ARCHITECTURAL REVIEW BOARD STAFF REPORT

Project #/Name	ARB-2026-00002: City Church Multi-Use Facility Final Site Plan
Review Type	Final Site Development Plan
Parcel Identification	061000000153A1
Location	1010 Rio Rd. East (Figure 1)
Zoned	Residential (R4), Entrance Corridor (EC)
Owner/Applicant	City Church Cville, Inc. (Chris Becker) /Mather Architects (John Daly)
Magisterial District	Rio
Proposal	To construct a multi-use facility adjacent to the existing church, to expand the parking lot, and to undertake related site improvements.
Context	The property contains an existing church, two parking areas, and a wireless facility. To the northeast and south of the property there are institutional uses including the Charlottesville Albemarle Technical Education Center (CATEC) and other churches. Adjacent properties to the east and west consist primarily of single-family residences, including the Dunlora and Greenbrier neighborhoods.
Visibility	The building will be readily visible from the Entrance Corridor.

ARB Meeting Date	May 4, 2026
Staff Contact	Margaret Maliszewski

Figure 2: Left: Outdated image with higher canopy presented 12/15/2025; Center and Right: Current proposal

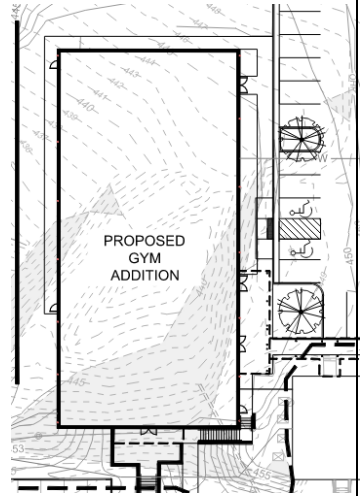
3	New structures and substantial additions to existing structures should respect the traditions of the architecture of historically significant buildings in the Charlottesville and Albemarle area. Photographs of				Consider modifying the heights of canopies and

historic buildings in the area, as well as drawings of architectural features, which provide important examples of this tradition are contained in Appendix A.	with the existing building and the broader architectural context of the County.		overlay), single-family detached residences along Rio in the Dunlora development, and the Rio Point apartments, though brick is more predominant along the corridor.	openings.	of the existing church. A slightly taller canopy (12’6”) is proposed over the entrance to the addition. The applicant has clarified that the recommendation to consider modifying the heights of the canopies was based on an outdated rendering. (See Figure 2.)	
4	The examples contained in Appendix A should be used as a guide for building design: the standard of compatibility with the area’s historic structures is not intended to impose a rigid design solution for new development. Replication of the design of the important historic sites in the area is neither intended nor desired. The Guideline’s standard of compatibility can be met through building scale, materials, and forms which may be embodied in architecture which is contemporary as well as traditional. The Guidelines allow individuality in design to accommodate varying tastes as well as special functional requirements.			The basic form of the addition – a rectangular box with a gabled roof – and the wall height are generally consistent with that of the existing church. However, the footprint of the addition is larger (70’ x 145.5’ vs. 40.1’ x 130.3’), the overall height is taller (38’10” vs. 33’10”), and the roof pitch is less steep. The white stucco walls are a stark contrast to the red brick of the church, and the black standing seam metal roof differs significantly from the gray shingles of the church. Most of the windows of the addition are horizontally oriented; those of the church are vertical. The result is an addition that looks more different and less unified with the existing church. Changes to building materials, colors, and/or details could increase compatibility. Roof and wall color changes that reduce the stark contrast between the church and the addition are recommended.		Canopy details are included in the architectural drawings, but they are not legible. The site plan and architectural elevations show the church canopy at different lengths.

- Staff recommend the following as the primary points of discussion:
1. The architectural design: building mass/scale, colors/materials, canopy heights
 2. Landscaping: potential utility conflicts, trees/shrubs near the proposed building
